**DAC 06/12/22 - NOTIFICATION OF 144 WOODFORD STREET, MINMI –
DA2018/01351 – DEMOLITION OF DWELLING, 962 LOT
SUBDIVISION INCLUDING ROADS, OPEN SPACE, STORMWATER,
UTILITIES AND BULK EARTHWORKS**

ITEM-30 **Attachment A:** CN Assessment Report

COUNCIL ASSESSMENT REPORT

PANEL REFERENCE & DA NUMBER	PPS-2019HCC006– DA2018/01351
PROPOSAL	<p>Subdivision of 6 lots into: 874 residential lots; 7 development lots for future residential development; 14 Local Centre Lots; 1 Neighbourhood Centre Lot; 2 Residue Lots; and 20 lots for road widening, public reserves and drainage reserves (proposed to be dedicated to Council);</p> <p>and</p> <p>The modification of DA2015/10393 pursuant to Section 4.17(1) of the Act to be 'Subdivision of Lot 2 in DP 1230960 and Lot 3 in DP1230960 into 292 lots, 7 large redevelopment lots ('super lots'), 4 drainage reserves, 3 public reserves and 2 residual lots, plus associated roads, infrastructure, bulk earthworks, open space and signage.</p>
ADDRESS	<p>Lot 100 DP1252590 – 144 Woodford St, Minmi Lot 5 DP 1230960 – 144 Woodford St, Minmi Lot 48 DP 115128 – 144 Woodford St, Minmi Part Lot 1 DP1156243 – 144 Woodford St, Minmi Lot 4 DP1253716 – 177 Woodford St, Minmi

FIGURE 7 – Lot 3807 – Proposed transfer to NPWS (Source – CN Mapping)

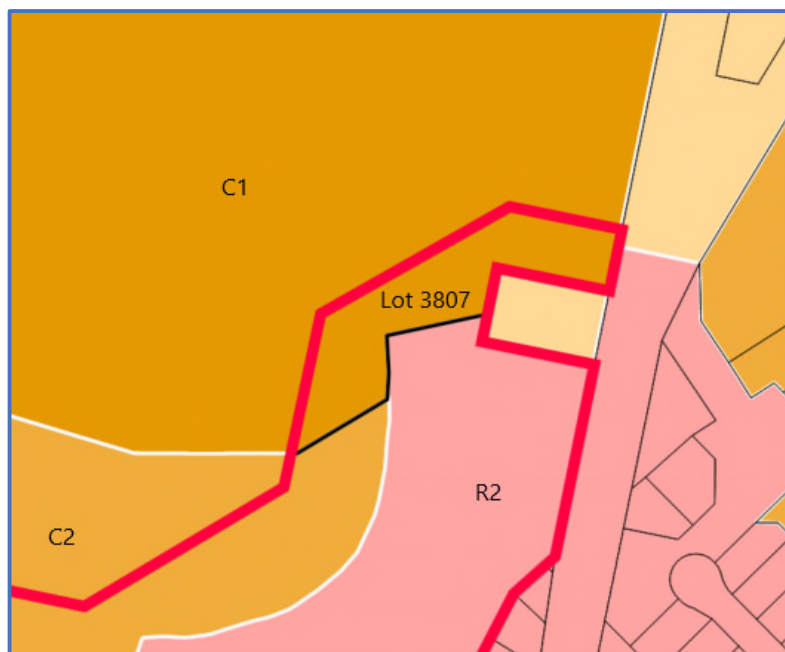
this, the applicant has agreed to create Lot 3807 (in Stage 38) and transfer that lot to the NSW Government for consolidation with the adjoining Stockrington State Conservation Area. **Figure 7** below shows the relationship of proposed Lot 3807 and the C1 zoned land.

FIGURE 10 – Possible Land Zoning Discrepancies – South-West Area (Source – SEE Figure 10)

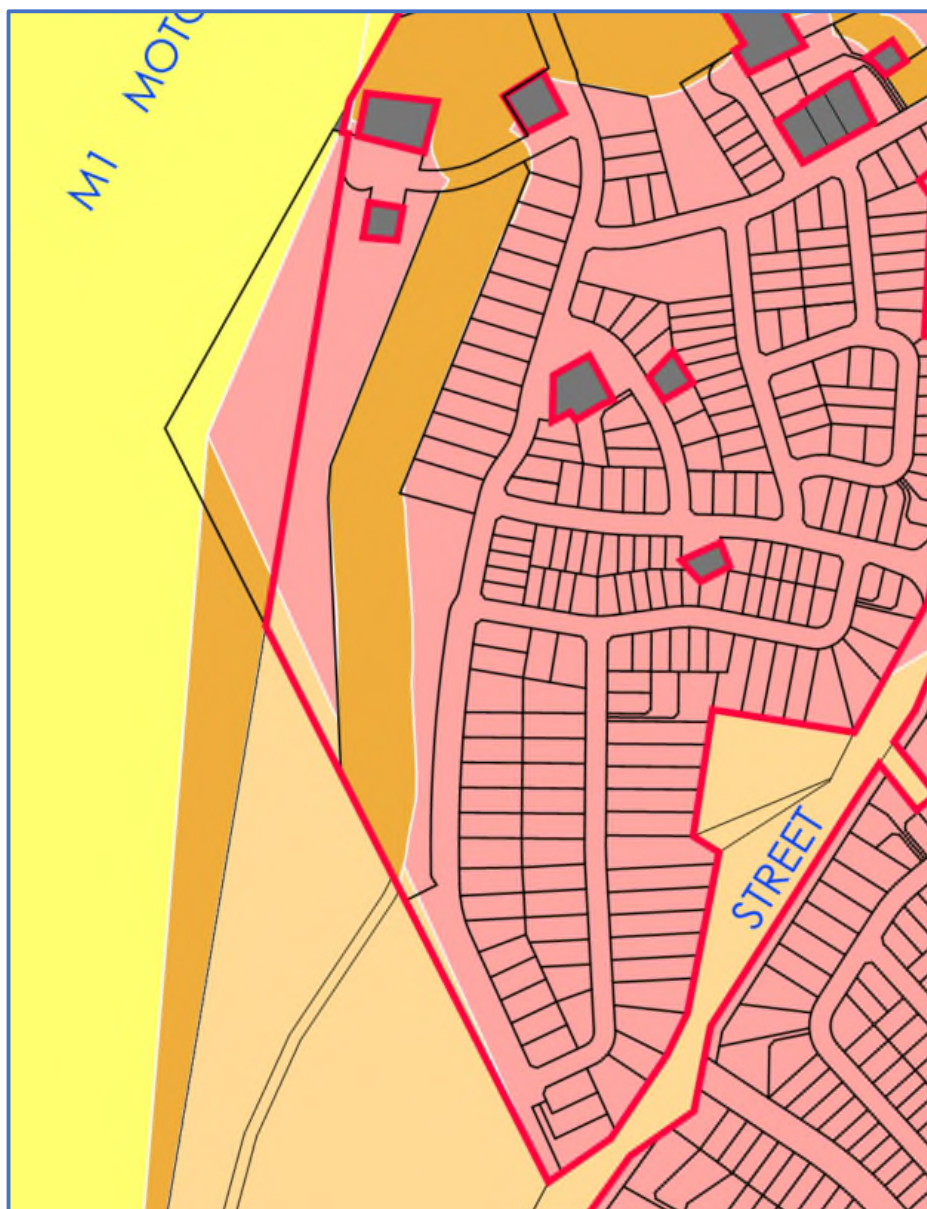
In the southwest corner of the development site, a number of seemingly unintentional discrepancies exist between the cadastral boundaries and land zone boundaries gazetted under both the NLEP2012 and the Lake Macquarie Local Environmental Plan 2014 (**LMLEP2014**). These discrepancies are evident in **Figure 10** below.

FIGURE 14 – Showing integration of Lot 49 DP115128 (Source – Subdivision Plans, Rev. S, June 2022)

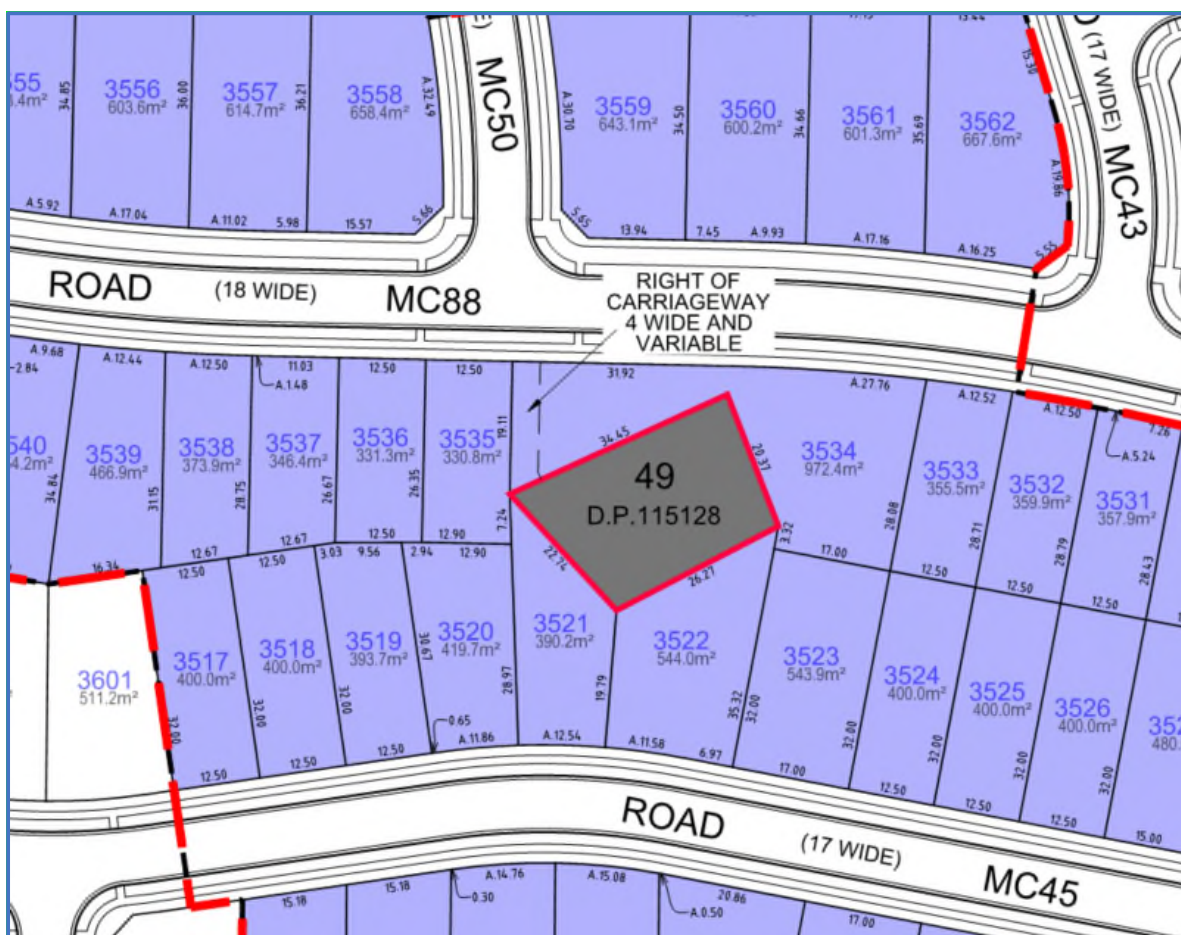
The further amended Subdivision Plans received by CN on 10 June 2022 titled '*Lot 49 in DP 115128 – Proposed Access Sketch*' (Ref: 239736(3)-ESK-067, Revision C dated 10 June 2022) and on 6 July 2022 titled Subdivision Plan Stage 35 (Ref.239736(3)-DA-118 Revision S, dated 25 June 2022) show a reconfiguration of the road and lot layout across the northern frontage of Lot 49 such that it now has no legal road frontage to the proposed public road but is instead wholly enveloped by proposed new allotments. This can be seen in **Figure 14** below which shows access to only be provided by a proposed Right of Carriageway 4m wide over proposed Lot 3534.

FIGURE 20 – Road Noise Daytime ((L_{Aeq}(15hr)(Daytime)) (Source – RTNA2020)

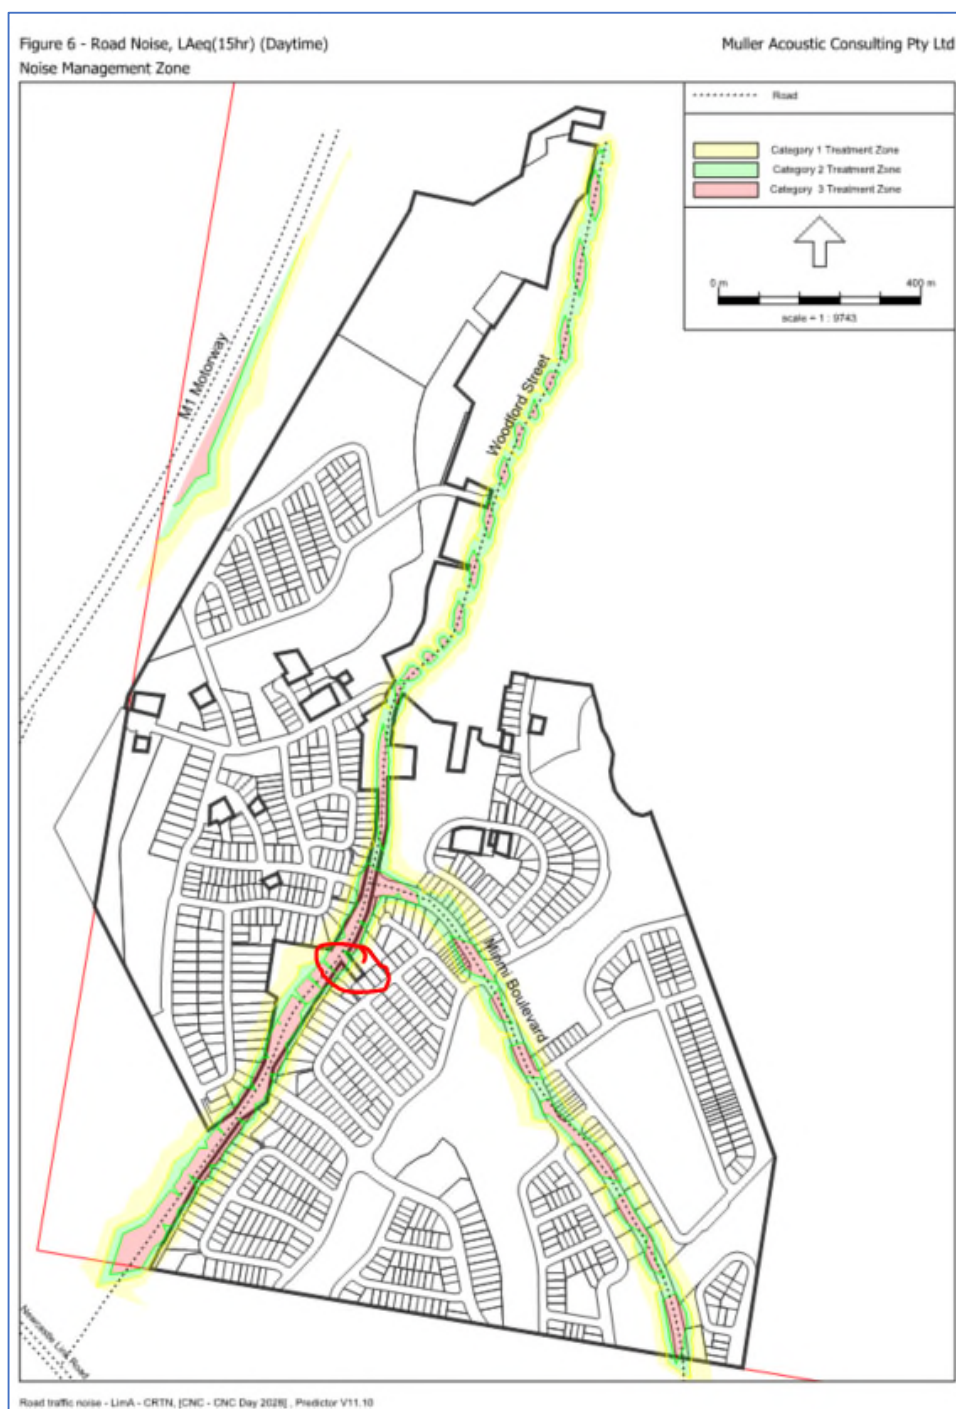
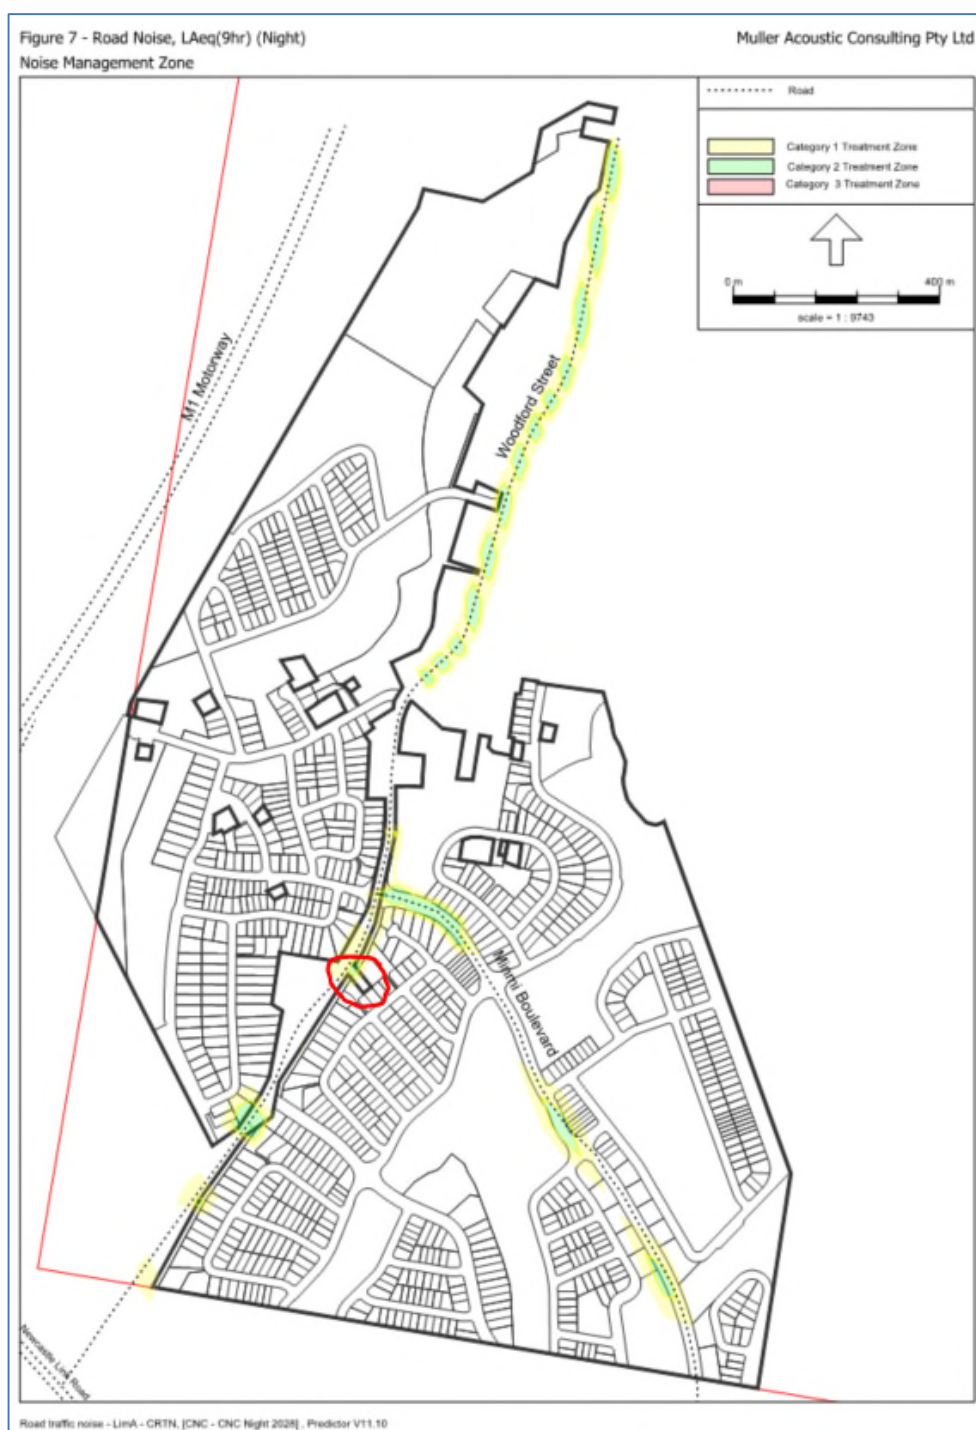
With regard to CN's request for Figures 6 and 7 of the RTNA2020 to be updated, in their first Response to RFI letter dated 10 June 2022 the applicant agreed to provide these to CN "once the final layout is known, noting that there are likely to be changes to the broader layout as a result of other (unrelated) matters raised by Council". No such updated plans were received in the two subsequent Response to RFI letters dated 30 June 2022 or 29 July 2022.

Figures 6 ((L_{Aeq}(15hr)(Daytime)) and 7 ((L_{Aeq}(9hr) (Night)) from the RTNA2020 are replicated below as **Figures 20** and **21** respectively. The location of 193 Woodford St is identified by the red circle.

FIGURE 29 (Example of Bulk Earthworks (Source – Concept Engineering Plan Sht 502))

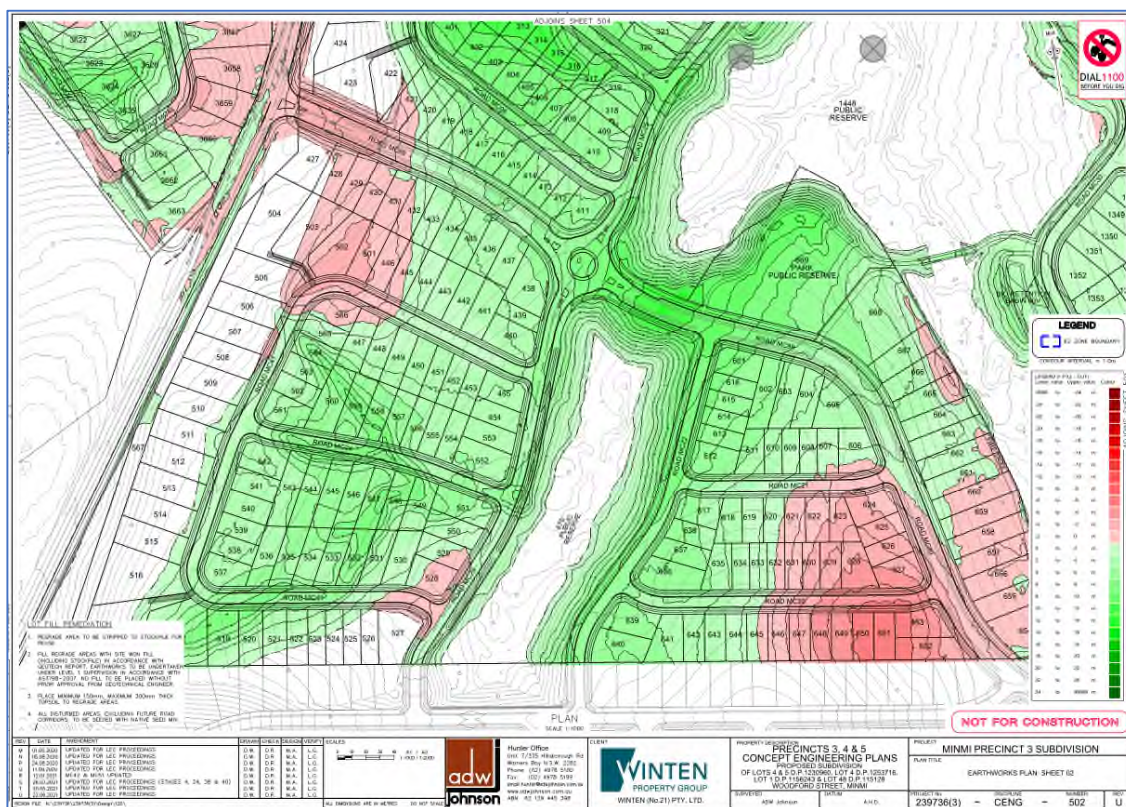
As can also be seen in **Figure 29**, significant earthworks are also proposed adjacent the southern boundary interface with land in LMCC LGA. Where this is at its most significance, is the southeast part of the development site in Stage 14 where Drawing Sht. 501 of the Concept Engineering Plans indicates a cut depth of approximately 9m. The application is silent on how these earthworks are to be achieved in a sustainable manner without impact on neighbouring lands in LMCC LGA.

Figure 35 – Increase in Peak Flood Depth 1%AEP, 1m tailwater, 100% blockage (Source BMT Report, Figure 6-4)

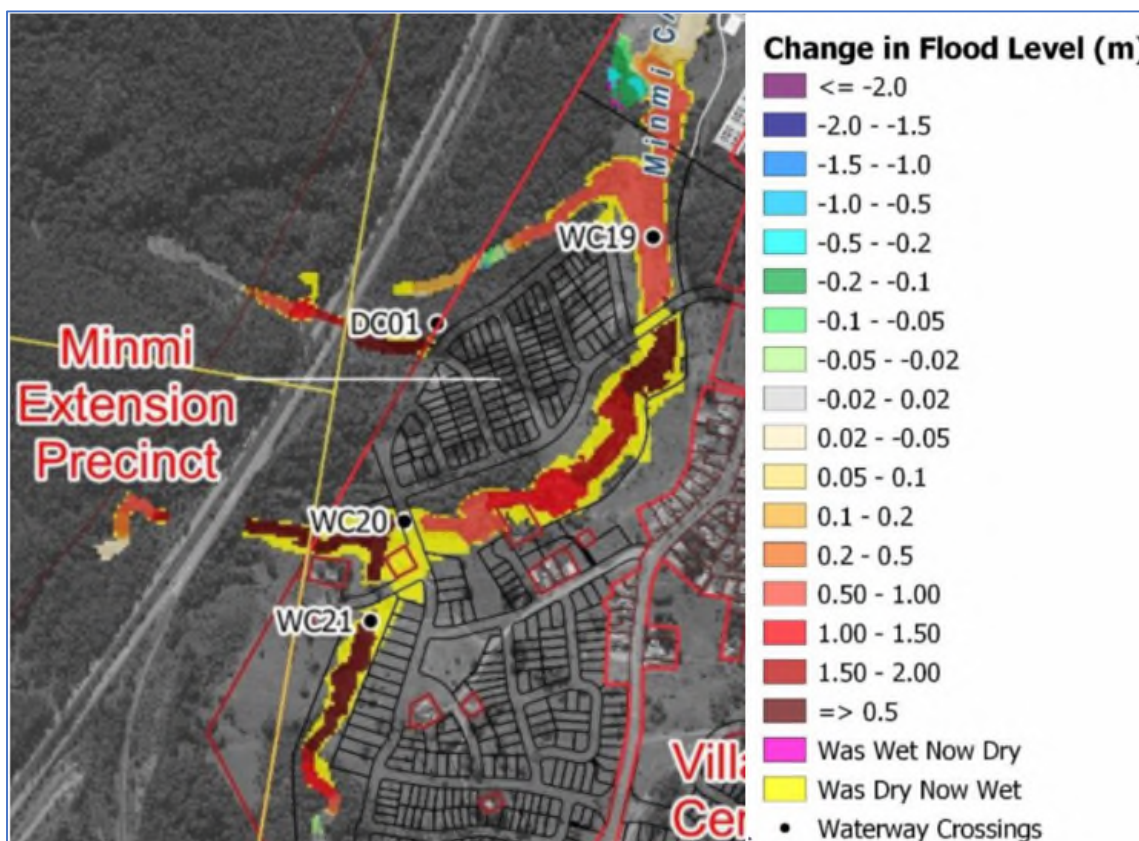
Interrogation of Figures 5-4 and 5.6 of the BMT report indicates that the proposed development will cause increases in 1% AEP flood levels in areas outside the boundaries of the site. Locations where this is evident are as follows. See **Figure 35** below showing the extent of increased flood depth (level) in the 1% AEP developed scenario assuming 100% blockage factor (see discussion below on blockage).

- Along the tributary of Minmi Creek that intersects the Minmi Extension Precinct and which is proposed as part of the development to be diverted via a diversion channel (ID DC01). The mapping in Figure 5-4 of the BMT report indicates that 1% AEP flood levels are predicted to increase in the adjoining property to the west for about 200 m and by up to 0.5 m. This is a significant impact and indicates that the development proposal does not conform to the requirements of the NSW Government's Flood Prone Land Policy as outlined in the Floodplain Development Manual (2005). Also, the extent and increase in changed flood level in this location may be further altered by the position taken by CN within this report not to support the proposed arrangements for the diversion channel (ID DC01) and the recommendation that this diversion be constructed as an appropriately sized open channel.

- Along a tributary of Minmi Creek extending upstream from waterway crossing WC20 in Figure 5-6 of the BMT report which drains the area to the west of the site. The mapping in Figure 5-4 of the BMT report indicates that 1% AEP flood levels are predicted to increase in the adjoining property to the west for a distance of about 200 m and by up to 0.5 m. This is a significant impact and indicates that the development proposal does not conform to the requirements of the NSW Government's Flood Prone Land Policy as outlined in the Floodplain Development Manual (2005).

Figure 38 – Flood Planning Area Developed Scenario (Source BMT Report, Figure 5-8)

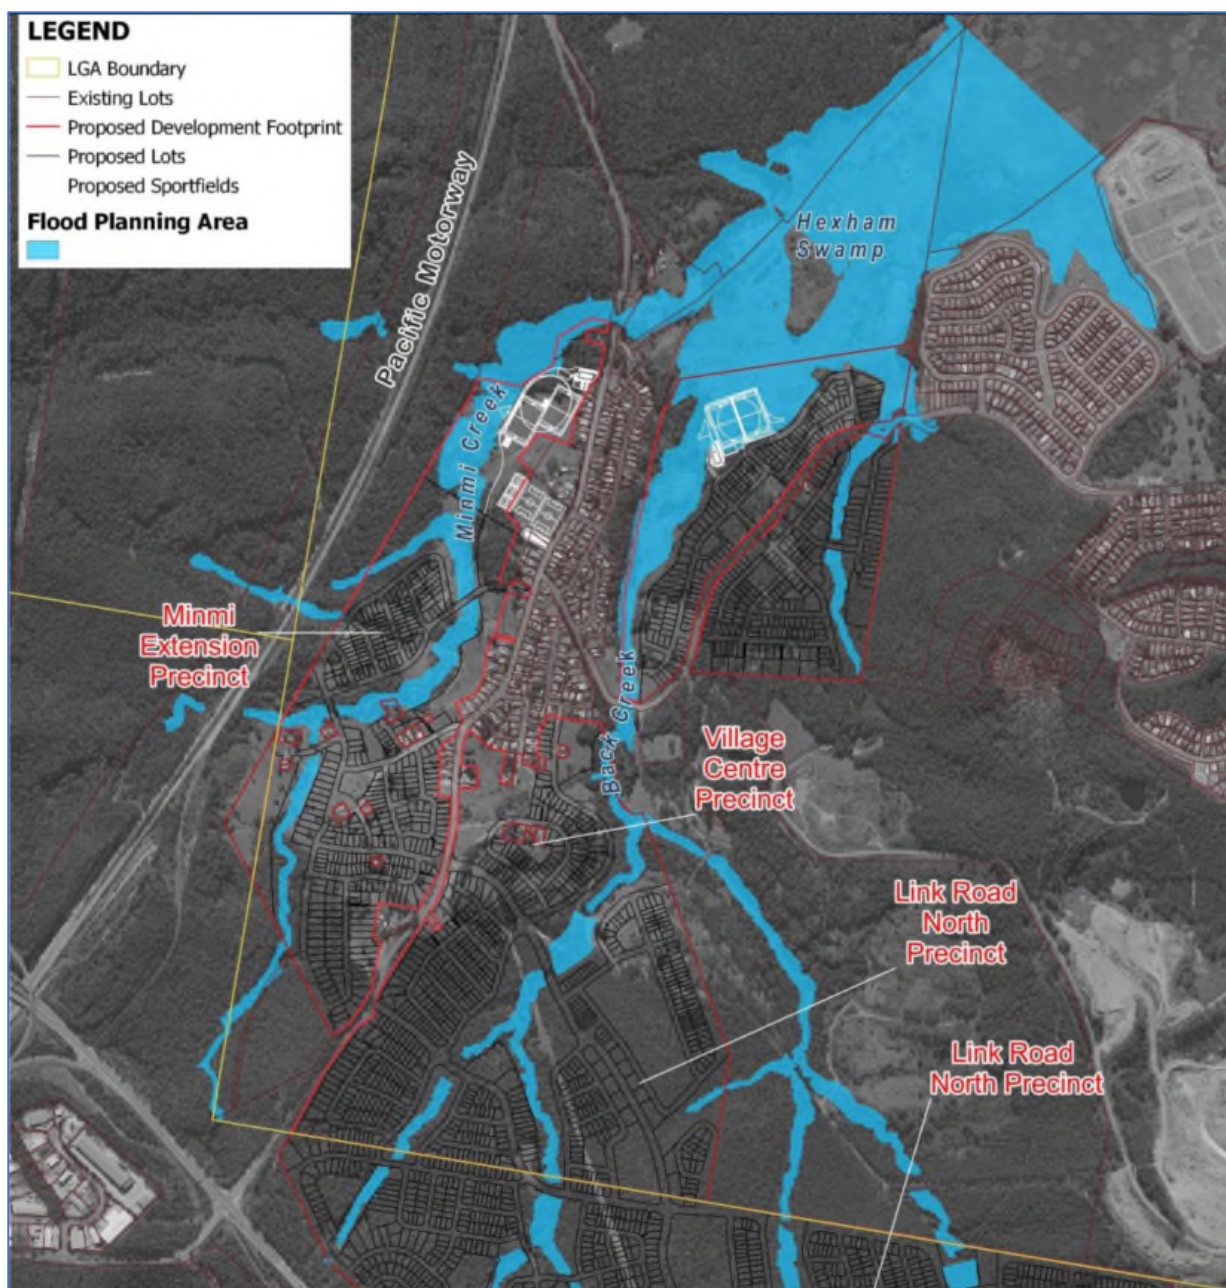
Flood Planning Area (FPA) mapping has been provided in the BMT Report (see extracts of FPA in **Figure 38** below). The mapping is accompanied by commentary that identifies the lots within the proposed subdivision that will fall within the FPA. This commentary indicates that for most of the residential lots that fall within the FPA, the extent of the lot impacted is at the rear of the lot, and that development in the affected area would be restricted by other planning controls such as rear boundary set back criteria. Accordingly, it can be concluded that residential development will not occur in areas below the Flood Planning Level.

Of the lots identified in conclusion b) of the BMT report only two are within the bounds of DA2018/01351 (14 Railway St (existing) and proposed Lot 665 in Stage 6).
